Access Compliance Report Public Rights-of-Way (Curb Ramps)

Main Street: ASCENSO_AVE		Cross Street: RIBERA_RD		Location:	NW
ADA ID: RPRK211117165948	Ramp Type:Type 1 - Perpendicular	Initial Pass/Fail: Fail	Overall Compliance: No	Severity Score:	15
Codes/Mitigation Info/Possible Solution			Field Measurements/Component Compliance

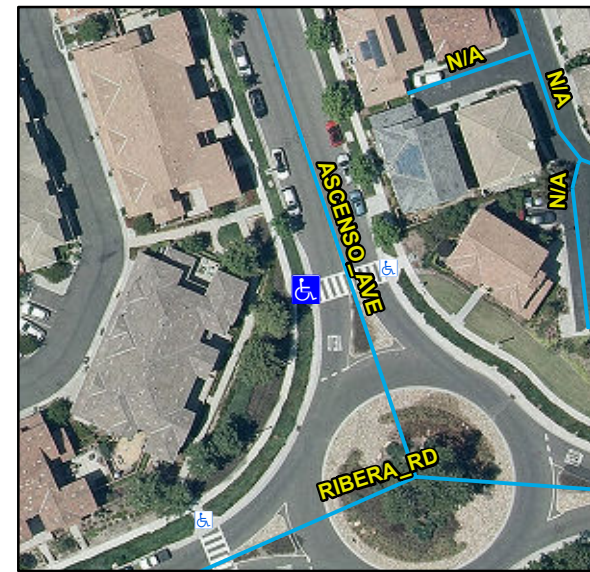
Compliance	Description	Data	Compliance	Description	Data
N/A	Ramp Length (in)	58	N/A	Flare Type LT	
Yes	Ramp Width (in)	60			N/A
No	Ramp Run Slope (%)	10.3	N/A	Flare Slope LT (%)	N/A
Yes	Ramp Cross Slope (%)	1.4	N/A	Flare Traversable LT	N/A
N/A	Landing Present	N/A	N/A	Flare Type RT	
N/A	Landing Length (in)	N/A			N/A
N/A	Landing Width (in)	N/A	N/A	Flare Slope RT (%)	N/A
N/A	Landing Run Slope (%)	N/A	N/A	Flare Traversable RT	N/A
N/A	Landing Cross Slope (%)	N/A	N/A	DWS Provided	N/A
N/A	Landing Movement Obstructed?	N/A	N/A	DWS Contrast	N/A
	Landing Movement Type	N/A	N/A	DWS Length (in)	N/A
N/A	Landing Shared	N/A	N/A	DWS Full Width	N/A
N/A	Clear Space	N/A	N/A	DWS Offset Left (in)	N/A
N/A	Clear Space To Crosswalk (in)	N/A	N/A	DWS Offset Right (in)	N/A
N/A	Marked Crosswalk 1	Yes	N/A	Marked Crosswalk 2	N/A
	Crossing 1 Direction	E		Crossing 2 Direction	N/A
	Marked Crosswalk 1 Width (in)	144		Marked Crosswalk 2 Width (in)	N/A

Remove & Replace Entire Ramp.

R304.2.2, STD 1115
